2003–2006 Ford Expedition 4.6/5.4 V8 Gas Engine Piston Replacement Compressor: 6512988

#103

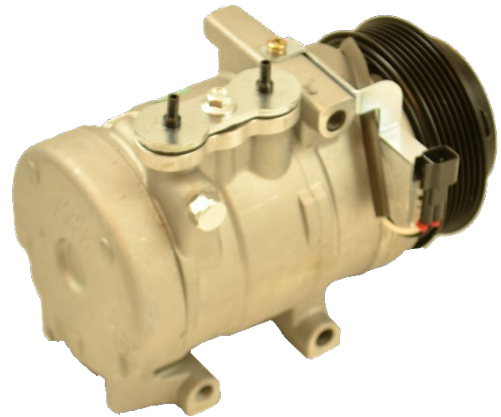
- gpd compressor 6511483 is an OE scroll style replacement compressor
- gpd compressor 6512988 is a redesigned piston style replacement compressor

The piston replacement compressor is a direct bolt-off, bolt-on replacement for the OE scroll style design. gpd's piston design is more tolerable of debris left in the A/C system and performs better at lower RPMs than the OE scroll design. Regardless of which compressor is used, gpd highly recommends flushing the system and replacing the condenser.

Please note: The gpd piston replacement compressor is prefilled with enough oil for the system. The prefilled amount in the piston replacement compressor will vary from the prefilled amount in the OE scroll style replacement. Refer to gpd Tech Tip #75, "Installing a Piston Replacement Compressor".
